JUNE 16, 2021

TRI-CITY MEDICAL CENTER

TCMC MRI

BID ADDENDUM NO. 1

PROJECT TITLE: TCMC MRI
PROJECT #: 01907.01/AGD 20-0001 SHEET NUMBER: E6-20
DRAWN BY: STAFF
CHECKED BY: ARS
SCALE: PER TITLE
DATE: 03/11/2020

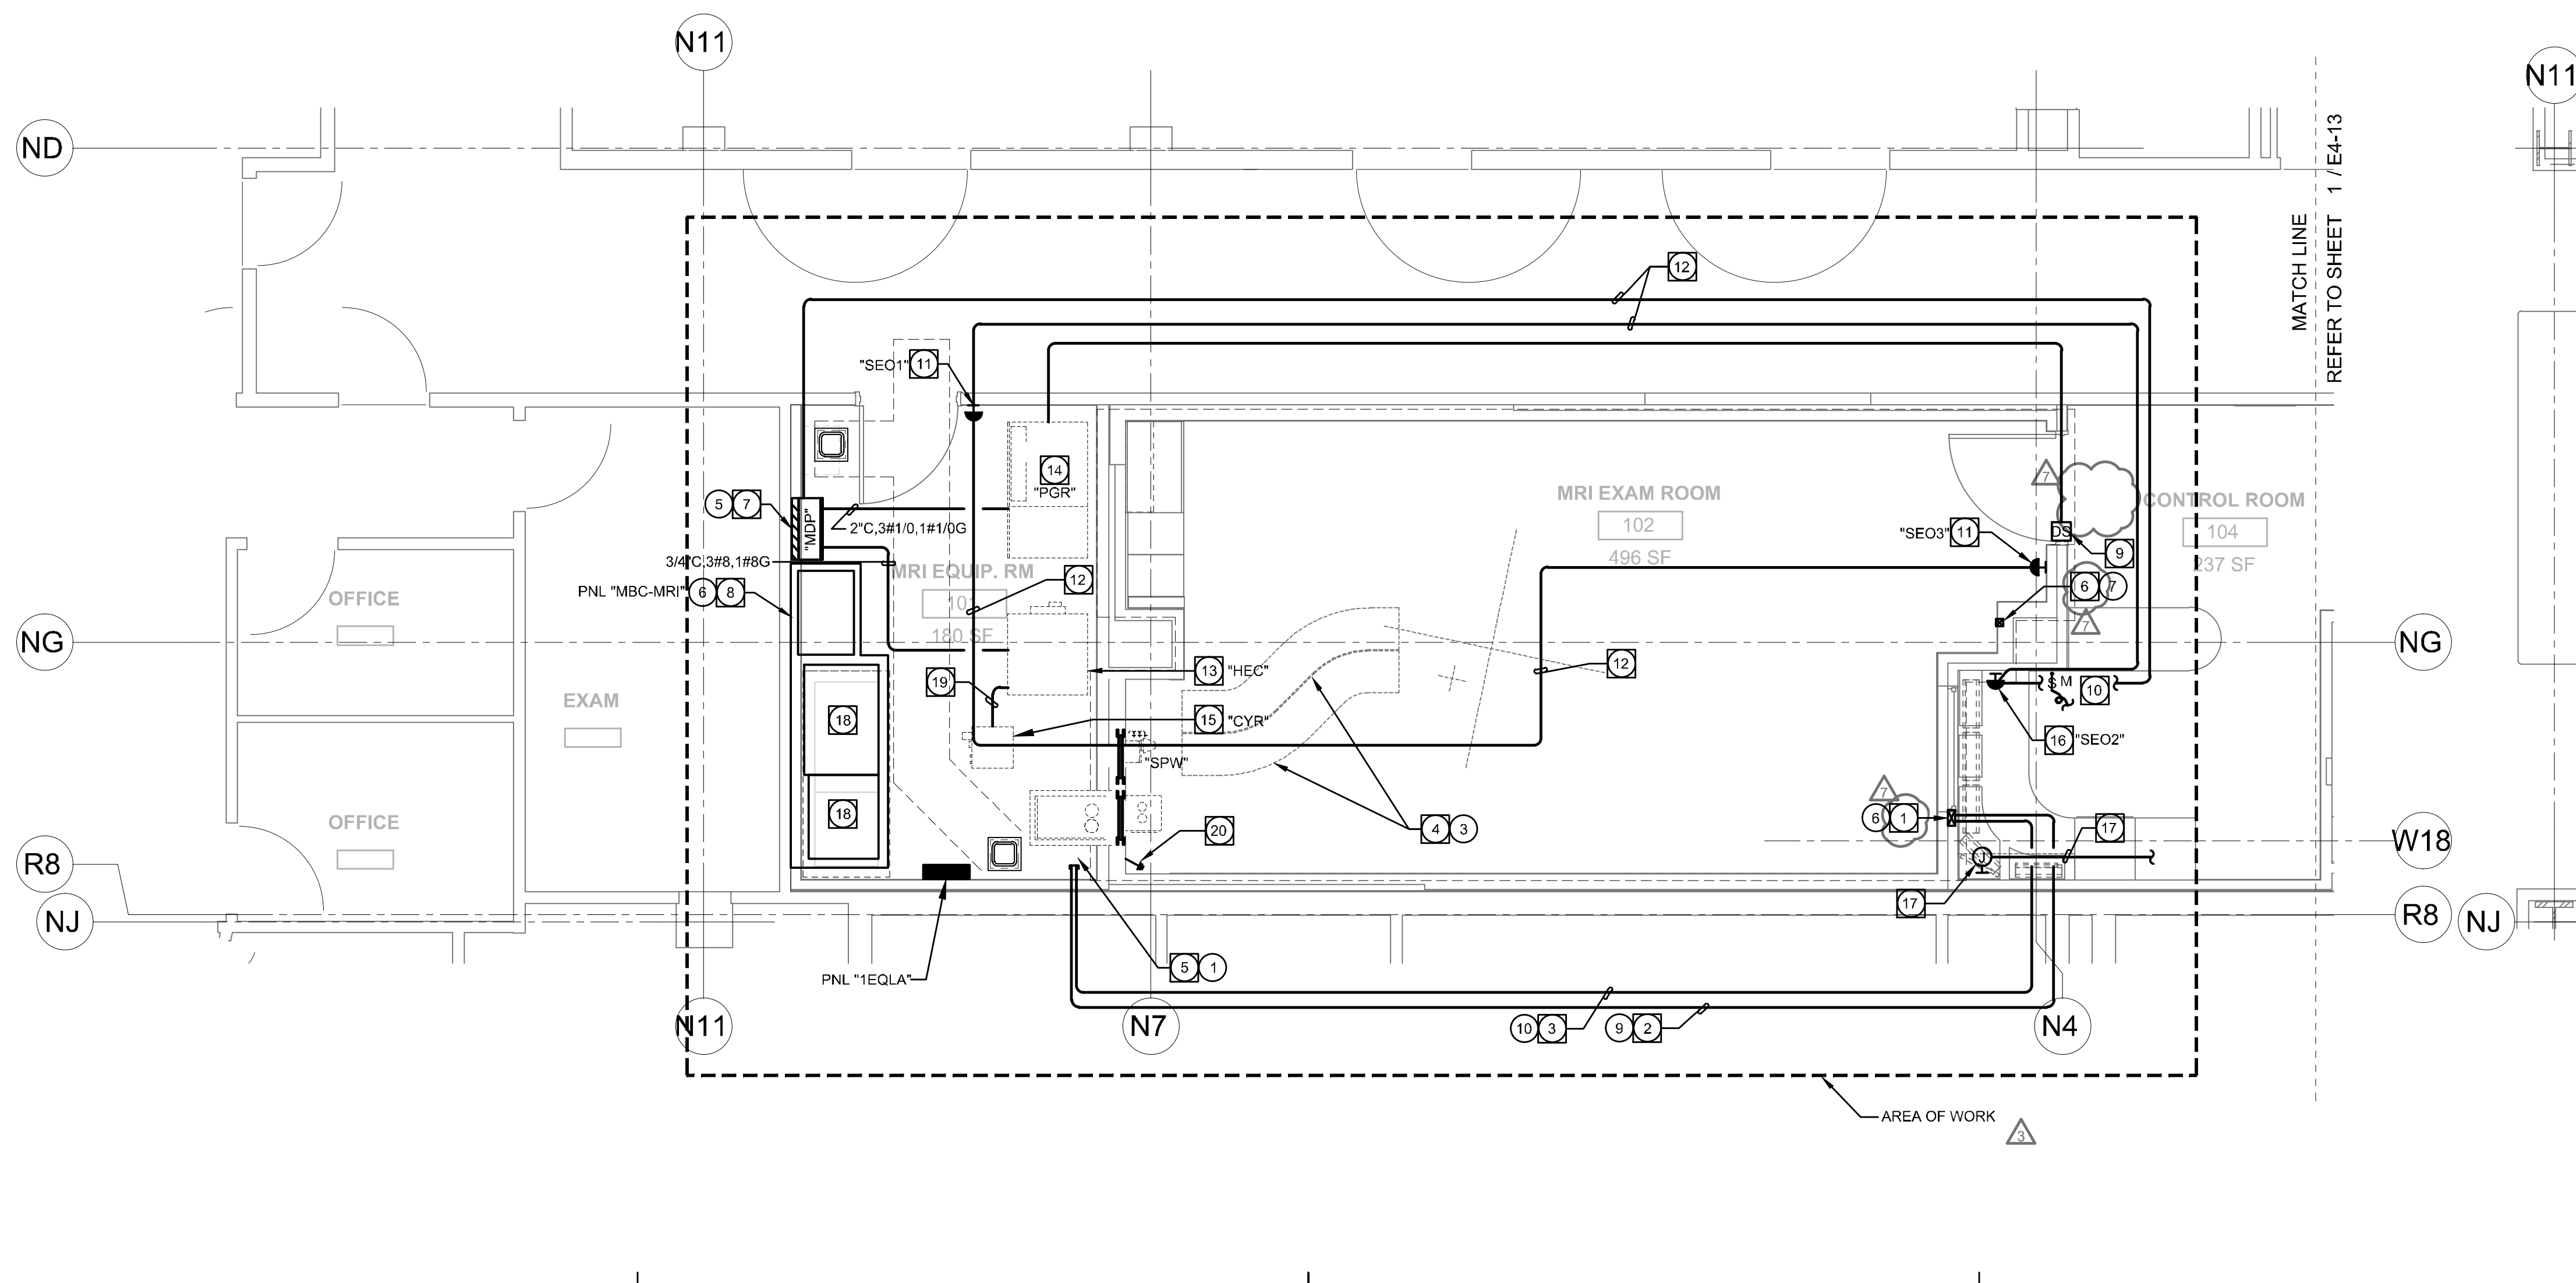
- Item No. 62 - Drawing E6-20:
Delete graphics for exit sign at entrance of control room on floor plan.
- Item No. 63 - Drawing E6-20:
Delete key note 1 on floor plan pointing to junction box on east side of MRI procedure room.
Add key note 6 on floor plan pointing to junction box on east side of MRI procedure room.
- Item No. 64 - Drawing E6-20:
Delete graphics for junction box, and key note 6 inside procedure room.
Add graphics for junction box, and keynote 1 and 6 inside wall separating control room and MRI procedure room.
- Item No. 65 - Drawing FP-101:
Add note 9 to General Notes: "Fire watch, paid for by the contractor, for any area under construction, and for any down time in phases not under construction shall be provided in accordance with specification 21 13 13 section 1.03.a.3."
